UNITED STATES PATENT AND TRADEMARK OFFICE

APPLICATION NO.	FILING DATE	FIRST NAMED INVENTOR	ATTORNEY DOCKET NO.	CONFIRMATION NO.
10/598,028	08/16/2006	Takao Wada	YMMRP0108US	9351
43076	7590	08/18/2009	EXAMINER	
MARK D. SARALINO (GENERAL)			CAILLOUET, CHRISTOPHER C	
RENNER, OTTO, BOISSELLE & SKLAR, LLP			ART UNIT	PAPER NUMBER
1621 EUCLID AVENUE, NINETEENTH FLOOR			1791	
CLEVELAND, OH 44115-2191				
			MAIL DATE	DELIVERY MODE
			08/18/2009	PAPER

Office Action Summary	Application No. 10/598,028	Applicant(s) WADA ET AL.
	Examiner CHRISTOPHER C. CAILLOUET	Art Unit 1791

DETAILED ACTION

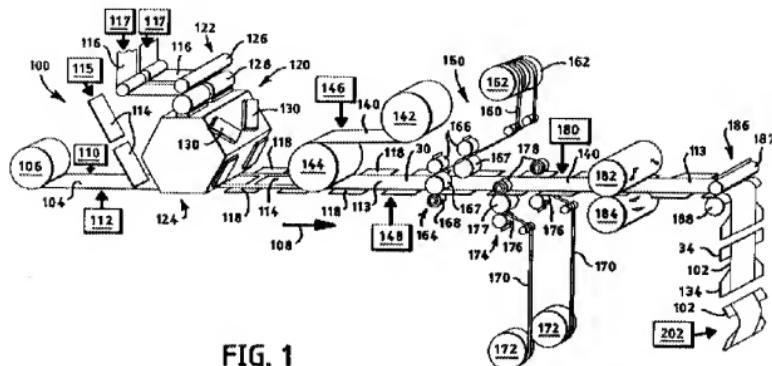
As to claim 1, Durrance et al. (Durrance) discloses a method of forming a diaper with side panels (Abstract; Fig. 1). As seen in Fig. 1 below, individual fastener strips

(118) are cut from webs of fastener material (116), rotated 90 degrees, spaced apart from one another, and then laminated to a web of body side liner material (104) (Fig. 1; paragraphs 110-112).

Durrance discloses that the webs of fastener material (116) may comprise of an elastic material such as a neck-bonded laminate (NBL) (paragraph 94), such as the NBL material formed by the method of Mormon (US 5226992) cited in the specification (Id.). Mormon discloses a method of making NBL material wherein an elastic material is bonded to at least one neckable material (Abstract). Mormon discloses one embodiment of a neck bonded material wherein an elastic material (72) is sandwiched between two neckable material layers (52, 82) by feeding said elastic material between the neckable layers (52, 82) to obtain a laminate (Fig. 3; column 9, line 54 – column 10, line 27).

FIG. 1

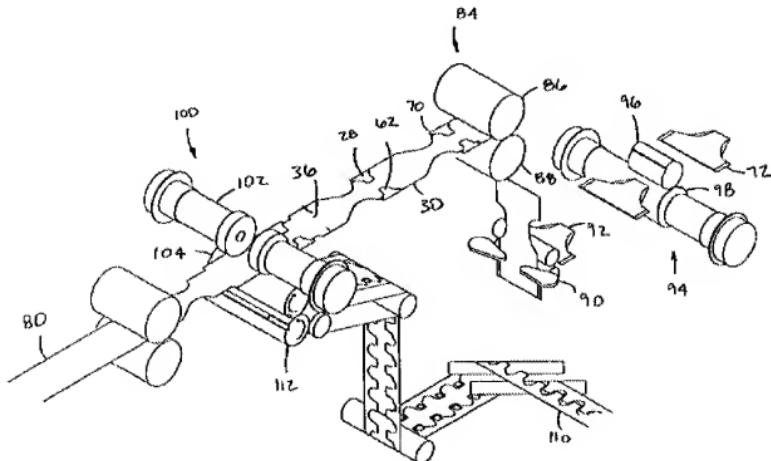
McNichols discloses a method of making absorbent articles with side panels attached to the waist region of said article (Abstract). As seen in Fig. 1 below, the method comprises of: cutting an elastic laminate (110) along a wave shaped cut-off line to form two laminates; the laminates are then rotated 90 degrees relative to the flow direction and separated from one another in a cross/width direction; the two laminates

are then cut in a predetermined interval in the flow direction by an cutting apparatus (112); and thereafter attached to each side of a web of interconnected diapers (80) (column 7, lines 4-20).

McNichols discloses that the webs of fastener material (110) may comprise of an elastic material such as a neck-bonded laminate (NBL) (column 13, lines 25-41), such as the NBL material formed by the method of Mormon (US 5226992) cited in the specification (Id.). Mormon discloses a method of making NBL material wherein an elastic material is bonded to at least one neckable material (Abstract). Mormon discloses one embodiment of a neck bonded material wherein an elastic material (72) is

sandwiched between two neckable material layers (52, 82) by feeding said elastic material between a the neckable layers (52, 82) to obtain a laminate (Fig. 3; column 9, line 54 – column 10, line 27).

If it is found that McNichols doesn't specifically disclose cutting the web in a flow direction to form two laminate webs, it is the position of the Examiner that it is well known in the art to slit a single web of fastener material in a flow direction to form two webs of fastener material to apply to a diaper chassis web.

FIG. 1

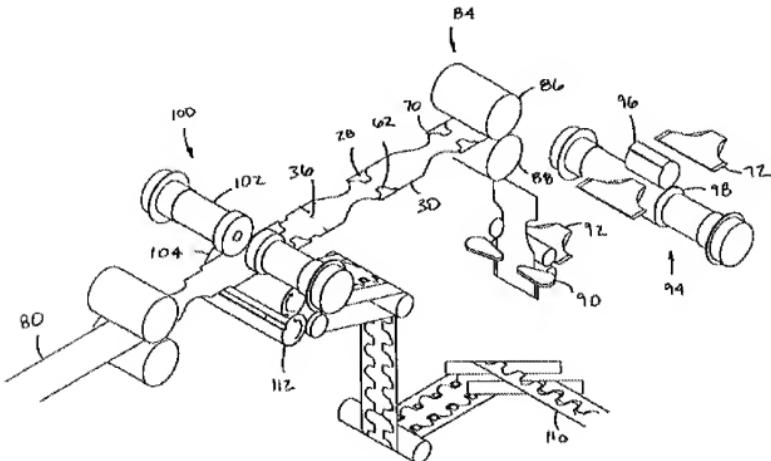
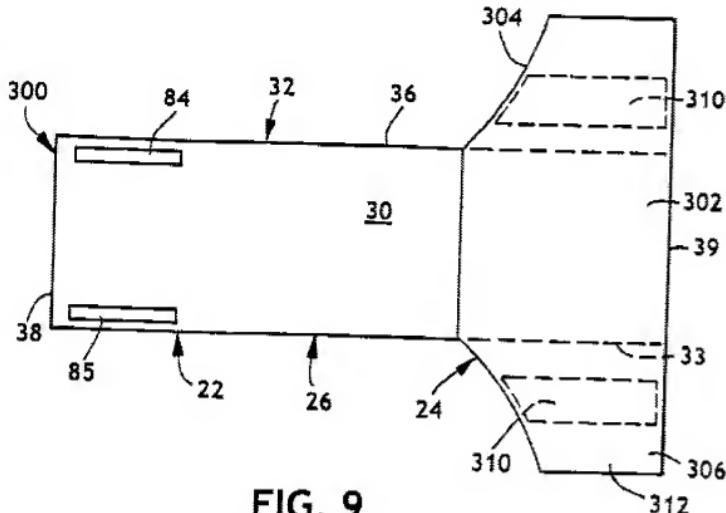
As to claim 2, McNichols discloses a method of making absorbent articles with side panels attached to the waist region of said article (Abstract). As seen in Fig. 1 below, the method comprises of: cutting an elastic laminate (110) along a wave shaped cut-off line to form two laminates; the laminates are then rotated 90 degrees relative to the flow direction and separated from one another in a cross/width direction; the two laminates are then cut in a predetermined interval in the flow direction by an cutting

apparatus (112); and thereafter attached to each side of a web of interconnected diapers (80) (column 7, lines 4-20).

McNichols discloses that the webs of fastener material (110) may comprise of an elastic material such as a neck-bonded laminate (NBL) (column 13, lines 25-41), such as the NBL material formed by the method of Mormon (US 5226992) cited in the specification (Id.). Mormon discloses a method of making NBL material wherein an elastic material is bonded to at least one neckable material (Abstract). Mormon discloses one embodiment of a neck bonded material wherein an elastic material (72) is sandwiched between two neckable material layers (52, 82) by feeding said elastic

material between a the neckable layers (52, 82) to obtain a laminate (Fig. 3; column 9, line 54 – column 10, line 27).

If it is found that McNichols doesn't specifically disclose cutting the web in a flow direction to form two laminate webs, it is the position of the Examiner that it is well known in the art to slit a single web of fastener material in a flow direction to form two webs of fastener material to apply to a diaper chassis web. Nease et al. (Nease) discloses a zero scrap method for manufacturing side panels for use with absorbent articles (Abstract). Nease discloses a method wherein a web of fastener material (201) is cut along a wave-shaped line (604) in the flow direction to produce a first (700) and second laminate (701) and there after said laminates are cut at a predetermined interval in the flow direction to obtain first and second cut panels (130) (Fig. 7; column 9, line 54 – column 11, line 14).

It would have been obvious to one of ordinary skill in the art at the time of the invention to incorporate the teachings of Nease into the method of McNichols because one of ordinary skill would have recognized the economic advantages of utilizing a zero-scrap method of producing side panels as taught by Nease.

Fig. 7

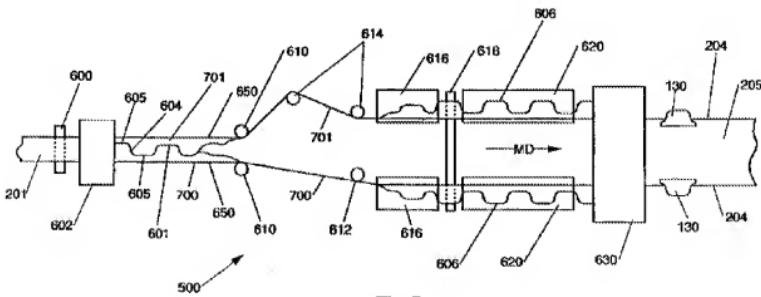
Olson fails to disclose the specific method utilized in forming the side panel (302) from the web of elastic material in the method of Mormon. Nease et al. (Nease) discloses a zero scrap method for manufacturing side panels for use with absorbent articles (Abstract). As seen in Fig. 7 below, Nease discloses a method wherein a web of fastener material (201) is cut along a wave-shaped line (604) in the flow direction to produce identical first (700) and second laminate (701) webs and there after said laminate webs are cut at a predetermined interval in the flow direction to obtain first and second cut panels (130); thereafter said panels are bonded to a diaper web/composite structure (205) (Fig. 7; column 9, line 54 – column 11, line 14). It would have been obvious to one of ordinary skill in the art at the time of the invention to incorporate the teachings of Nease into the method of Olson because one of ordinary skill would have recognized the economic advantages of utilizing a zero-scrap method of producing side panels as taught by Nease.

Incorporating the teachings of Nease into the method of Olson would result in two identical laminate webs, when cut at a predetermined interval in the flow direction would form identical panel members (302) in the opposite orientation relative to one another, first and second panels on one side, third and fourth panels on the opposite side. Therefore, before applying the panel members (302) to the composite structure (30), said panels would need to be rotated 90 degrees relative to the flow direction. It is the position of the Examiner that methods of rotating and applying a discrete material member to a web of material is well known in the art and would have been obvious to one of ordinary skill at the time of the invention. Pohjola discloses a method and apparatus for cutting strips of material (18) from a web (12), holding and rotating said strips 90 degrees on a transfer roll (28), and placing/laminating said strips onto a moving second web of material (14) (Fig. 1; column 3, lines 7-53). It would have been obvious for one of ordinary skill at the time of the invention to incorporate a known successful method of rotating and placing a discrete side article onto web of material, such as the method of Pohjola, into the method of Olson because such a modification would have been well within his technical grasp.
